From: Mary Pope <popema236@gmail.com>
Sent: Tuesday, September 29, 2020 2:04 PM
To: City Council; Nadia Khan; Michael Gleba
Subject: Fwd: 432 Dedham Street - Retaining Wall (Item #316-20)

From: Mary Pope <popema236@gmail.com>
Date: Tue, Sep 29, 2020 at 12:06 PM
Subject: 432 Dedham Street - Retaining Wall
To: David Geffen <david@geffenc.com>

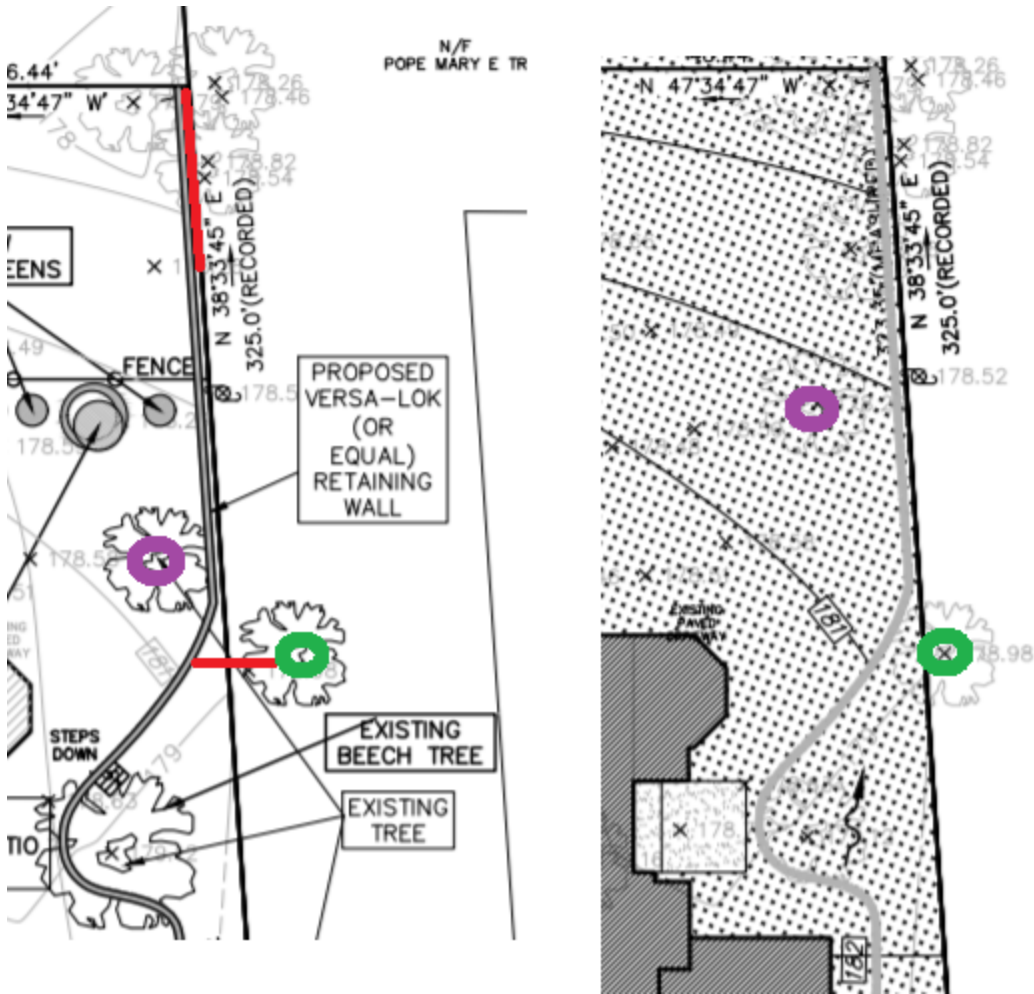
Thanks for the updated retaining wall plan. Definitely an improvement. After mulling it over a bit and doing a bit of online reading, I think it can be even better and hope you agree.

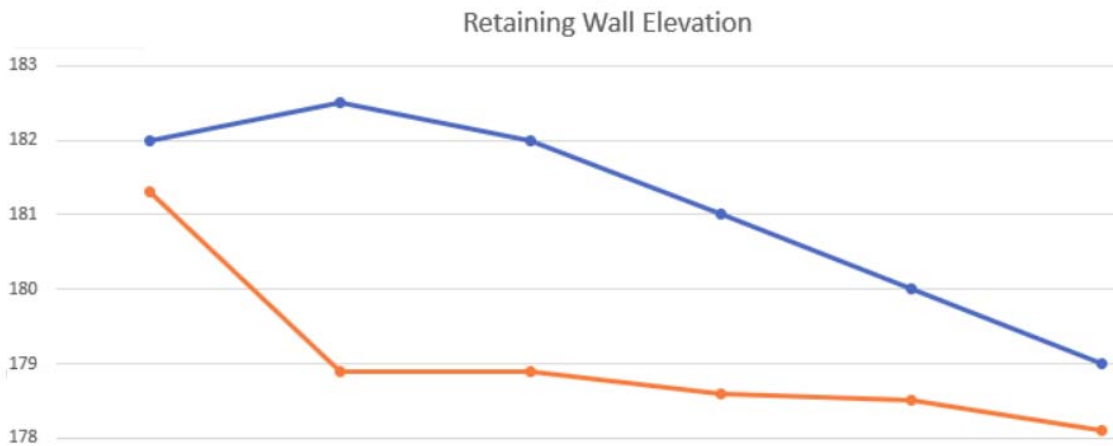
- As an advocate for all the trees I would recommend the retaining wall goes around the big trees on your property that you are intending to save. I fear that they will not do well with the trenching and fill as the links above suggest that the top six inches of roots are particularly significant to tree health. You could also create wells around them and take other mitigating actions instead. Neither of us are experts so I would suggest you consult an arborist about the suitability of your plans.
- As an advocate for my trees, I expect your plans should not damage the health of my trees. There are two big ones (8' and 5' 6" circumference measured above my head) at or near the property line and it would presumably be better to distance the retaining wall from them by more than one or two feet.

For reference here are two drawings from your plans. I included both because it shows the trees in different locations. The green circle is my 2 1/2 ft diameter oak. The purple circle is one of the large trees you are keeping.

Here's the elevation profile of current (orange line) and proposed (blue line). The fill levels range from 3 1/2 ft to 9 in.
